To: Design Review Board
From: Scott Guter, AICP, Senior Planner
Date: November 25, 2019
File No.: DRV19-00461
Subject: **112 LAKE ST S MIXED USE
DESIGN RESPONSE CONFERENCE**

DESIGN REVIEW CONFERENCE II

112 LAKE STREET S | KIRKLAND, WA
DECEMBER 2, 2019 | DRV19-00461

1. COMMERCIAL STREET FRONTAGE | RETAIL C DEPTH

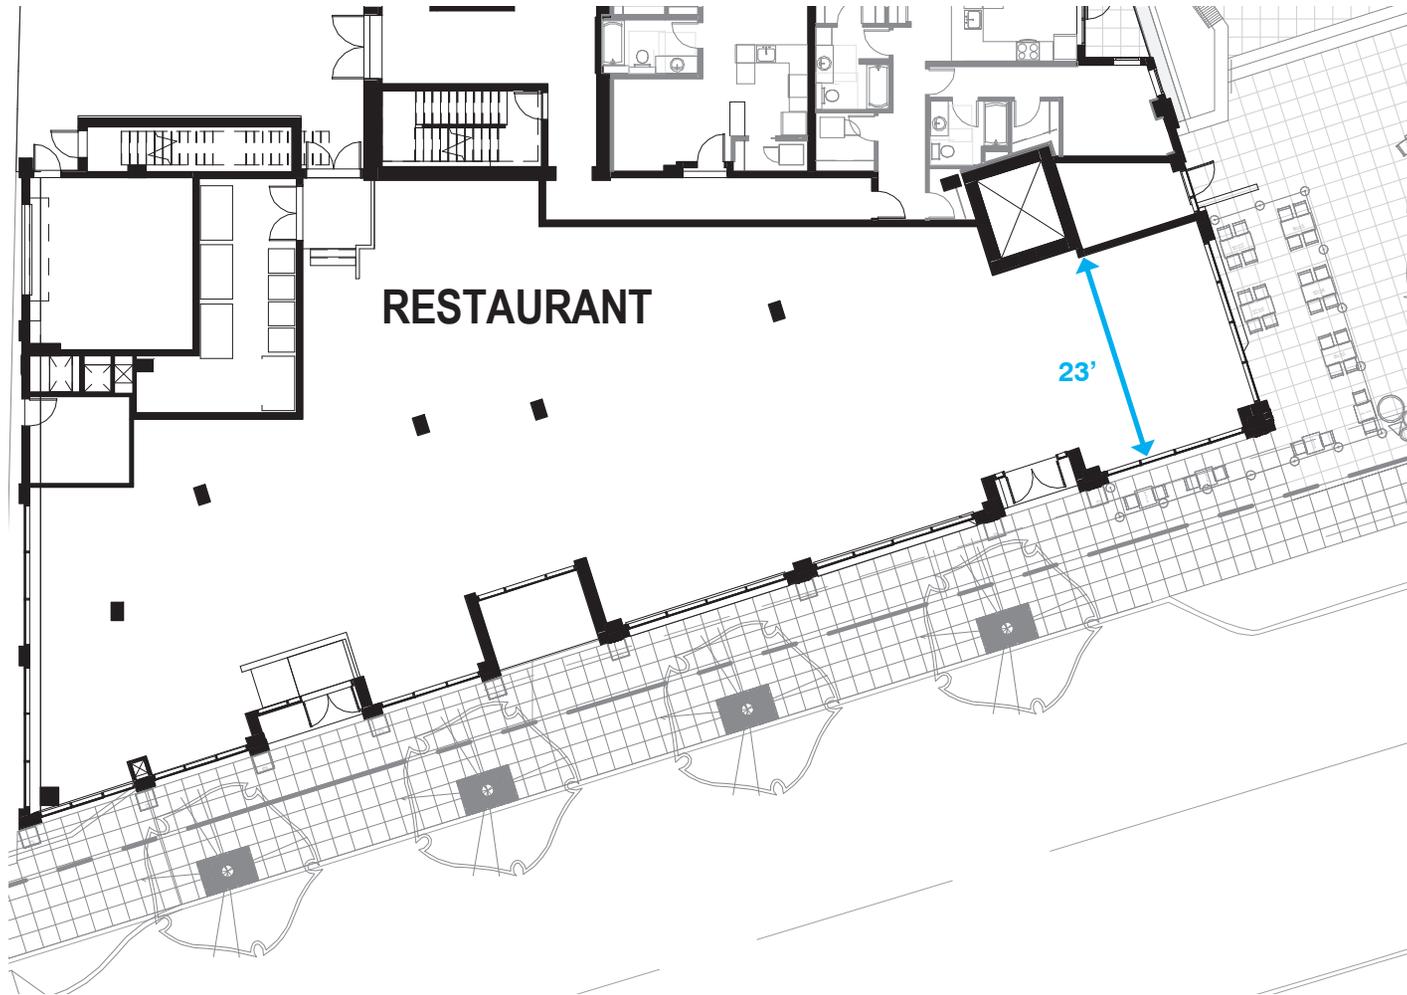
DRB Discussion: The DRB was in general support of the direction the applicant has taken but wanted the applicant to work on the parapet rhythm of Retail C. They also wanted more information on how the decking above the storefronts will operate and be treated.

1. Retail C Depth

Retail depth has been increased to exceed the minimum 20' depth requirement by revising the circulation routing previously restricting the retail depth.
